UNITED STATES PATENT AND TRADEMARK OFFICE

APPLICATION NO.	FILING DATE	FIRST NAMED INVENTOR	ATTORNEY DOCKET NO.	CONFIRMATION NO.
10/075,216	02/14/2002	Michael Alois Kolowski	DN2002024	7021

Office Action Summary	Application No.	Applicant(s)	
	10/075,216	KOLOWSKI ET AL.	
	Examiner	Art Unit	
	Steven D. Maki	1733

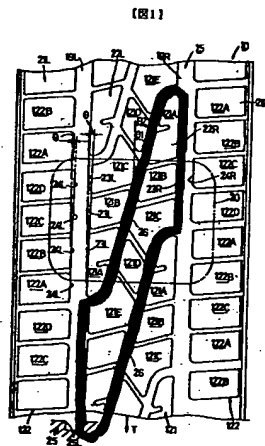
Lindner et al discloses a tread having tread elements oriented into a first shoulder row, a second shoulder row and a central row wherein the central row comprises circumferentially repeating arrays of tread elements. Figure 2 of Lindner et al is reproduced below with markings added by the examiner. The markings added by the examiner indicate one of the central arrays of tread elements.

As to claim 17, the central arrays of tread elements overlap. See figure 2 of Lindner et al.

As to claims 18-20 and 23, each array is defined by an "upper boundary groove" and a "lower boundary groove" which connect at the axially outermost positions of the array where groove 16 and groove 28 intersect (each boundary groove comprises one of the connecting grooves 28). As to acute angle, Lindner et al teaches inclining the connecting groove 28 at 40-60 degrees and inclining groove 16 at 45-65 degrees at intermediate portion C. The "boundary grooves" therefore can form an angle of 85 degrees (an acute angle). As can be seen from figure 2, each array has smaller tread elements at the ends of the array. Also, the boundary grooves are non-linear / curvilinear. See figure 2 and col. 1 line 67 to col. 2 line 29.

Japan '207

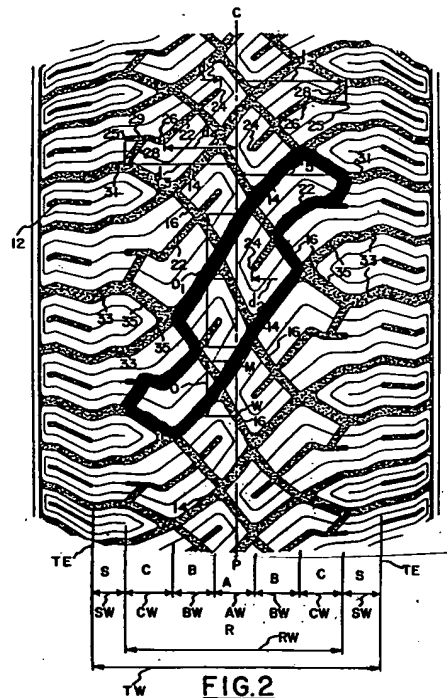
The claimed tread reads on the tread having the tread pattern shown in figure 1. The claimed central array reads on the "central array" comprising seven blocks 121A, 121B, 121C, 121D, 121E, etc. Japan '207 teaches delimiting the central array using slant grooves 26 and portions of grooves 19L, 19R. The slant grooves have oppositely curved end sections. The slant grooves 26 are inclined at an angle of 1-15 degrees with respect to the circumferential direction and the portions of grooves 19L, 19R are slightly inclined at an angle of for example 2 degrees. Figure 1 of Japan '207 is reproduced below with markings added by the examiner:

claim 29, Japan '207's teaching to taper the blocks adjacent grooves 19L, 19R at 2 degrees forms a shoulder groove as claimed.

As to the remaining claims: The circumferential ends of two adjacent slant grooves 26 are connected by a slightly inclined portion of a circumferential groove 19L, 19R. The claimed first boundary groove reads on the combination of one of the slant grooves 26 and the slightly inclined portion of one of the circumferential grooves (19L, 19R) extending from one end of the one slant groove to one end of the other slant groove. The claimed second boundary groove reads on the other slant groove 26 and the other of the slightly inclined portion of the circumferential grooves (19R, 19L) extending from the other end of the other slant groove to the other end of the one slant groove. The curved portion of slant groove 26 intersects the slightly inclined portion of the circumferential groove at an angle less than 90 degrees (an acute angle). As to curvilinear, note the oppositely curved portions of slant groove 26. Claim 23 fails to require the boundary grooves to be curvilinear throughout their length. The tread pattern in figure 1 is non-directional.

Applicant's argument that Japan '207 shows an aligned rather than overlapping orientation is not persuasive since (1) none of claims exclude "aligning" the central arrays and (2) Japan '207's central arrays are overlapping as claimed. For example block 121A (a block at the end of one array) is adjacent a block 121D (a middle block of another array).

As to applicant's comment that Japan '207's arrays result in a straight line circumferential boundary groove, the examiner notes that Japan '207's teaching to taper the block at 2 degrees forms an irregular boundary groove condition and prevents the "shoulder groove" from having straight circumferential edges.

Applicant argues that the boundary grooves diverge instead of converge. Applicant is incorrect. The boundary grooves converge such that they intersect at the tip of block 121A.

FIG. 3

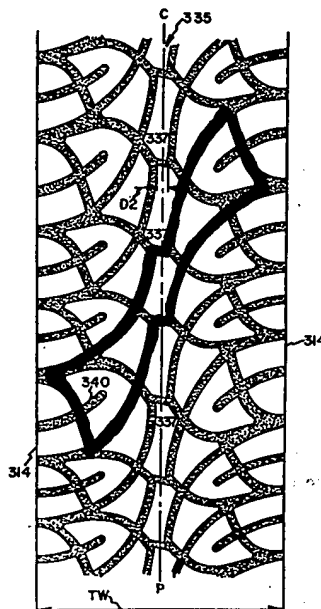
The claimed tread is anticipated by the tread shown in figure 3. Figure 3 of Fontaine et al is reproduced below with markings added by the examiner:

The markings added by the examiner indicate one of the central arrays of tread elements.

As to claim 26, it would have been obvious to incline the grooves in Fontaine et al such that the centerline is inclined at an angle of less than 30 degrees in view of Fontaine et al's teaching to incline the grooves near the EP at an angle of not greater than 15 degrees (the illustrated inclination appears to be at 30 degrees)
